**COMMENTS FROM THE ENGINEERING SERVICES DEPARTMENT FOR:
APPLICATION FOR SUBDIVISION AND CONSENT USE: ERF 1447, SANDBAAI**

PROPOSED DEVELOPMENT OF THE STAND 1447 IN SANDBAAI : WATER AND SEWER SYSTEMS

Figure SBS-1447
Proposed Development
Stand 1447
Existing Sewer System

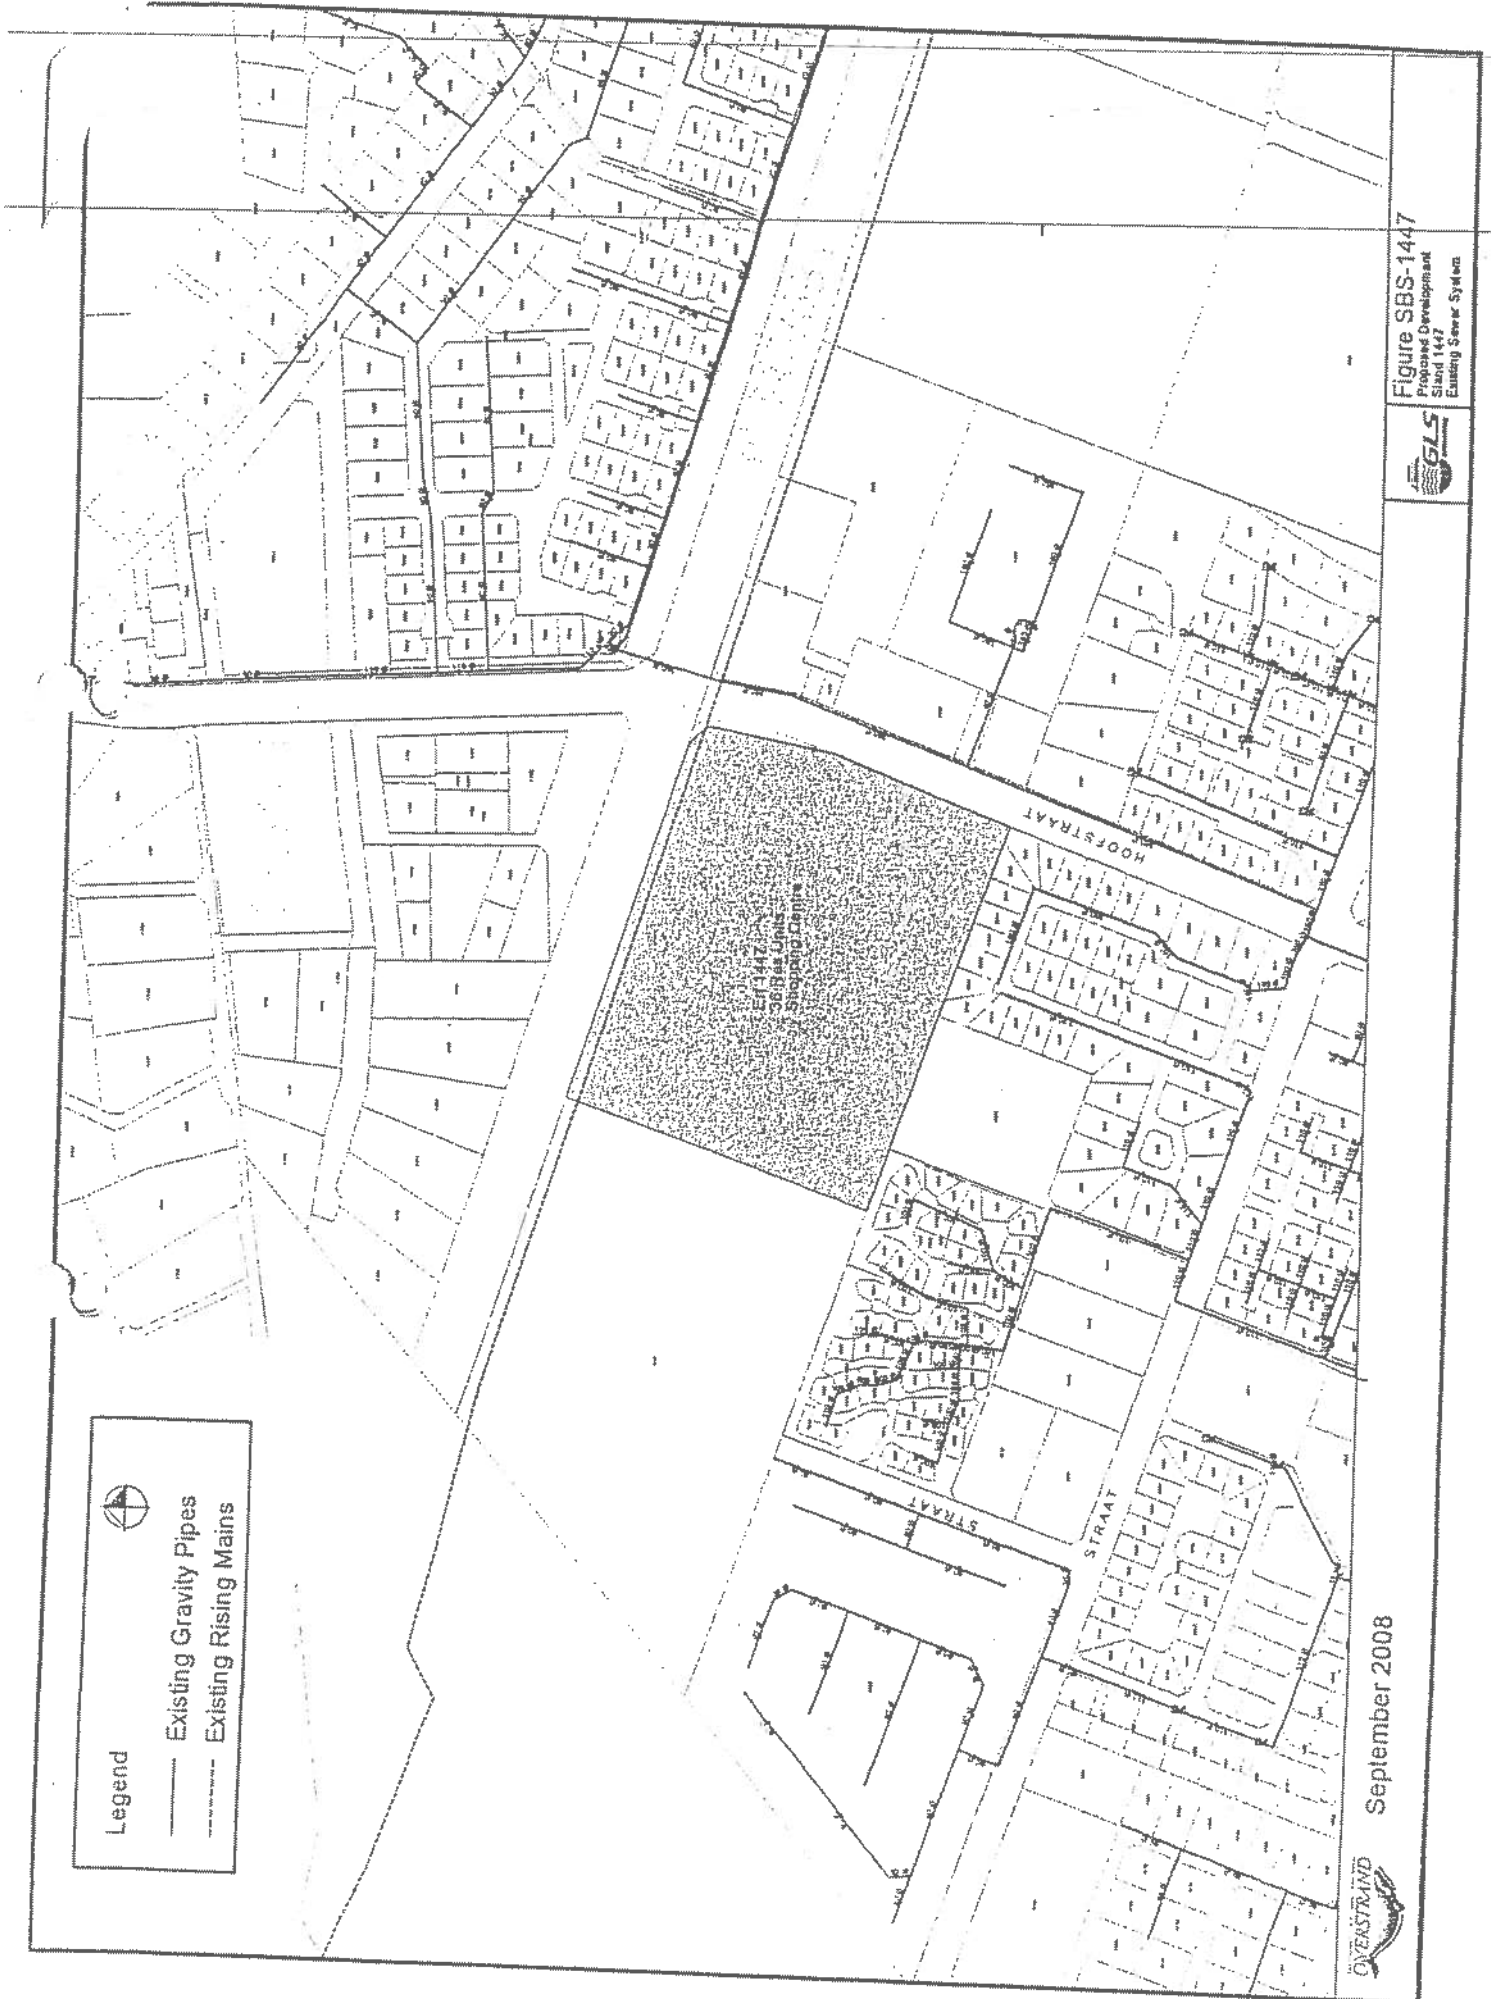
The sewer reticulation system would be sufficient to serve the proposed development. It is proposed that the sewer should discharge into the 160 mm \varnothing gravity pipe in the Main Street of Sandbaai.

Figure SBW-1447
 Proposed Development
 Street 1447
 Existing Water System

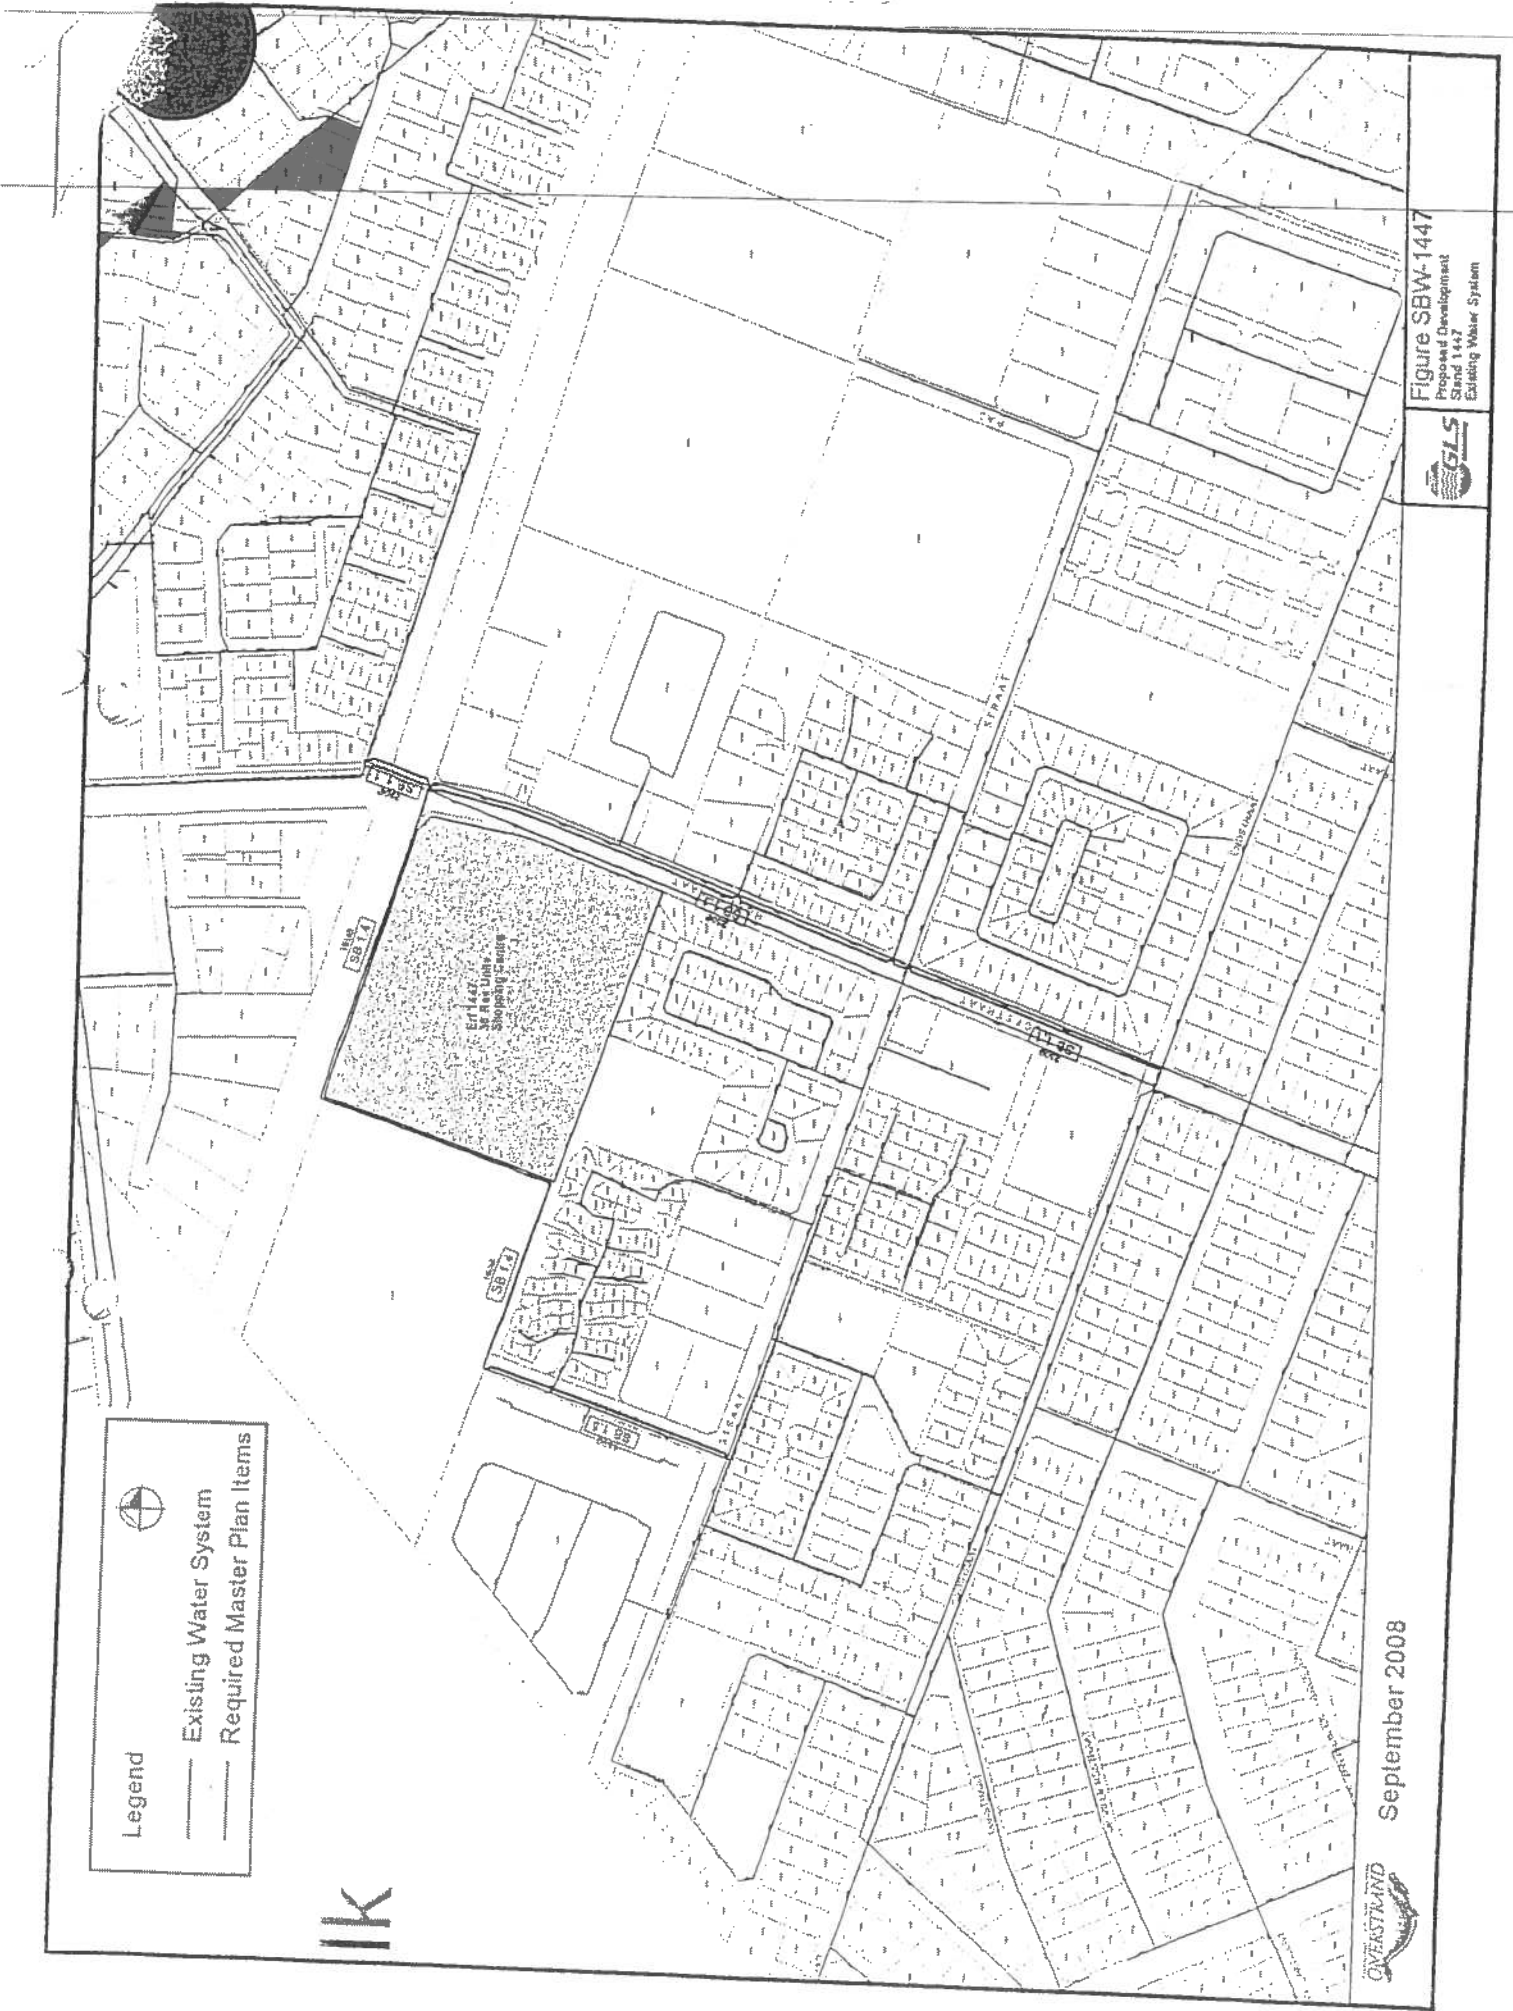
The occurrence of development in the vicinity, such as on adjacent erven 1448, 1460, 1461, 1600, 1601 and 1620 requires that the following Master Plan items (Refer to "Water Master Plan, March 2006" - CES), as indicated on Figure SBW-1447, be implemented in order to serve the proposed developments:

- i. SB1.1 - 690m x 250mm Ø parallel pipe reinforcement
- ii. SB1.4 - 610m x 160mm Ø parallel pipe reinforcement
- iii. SB1.5 - 200m x 160mm Ø parallel pipe reinforcement
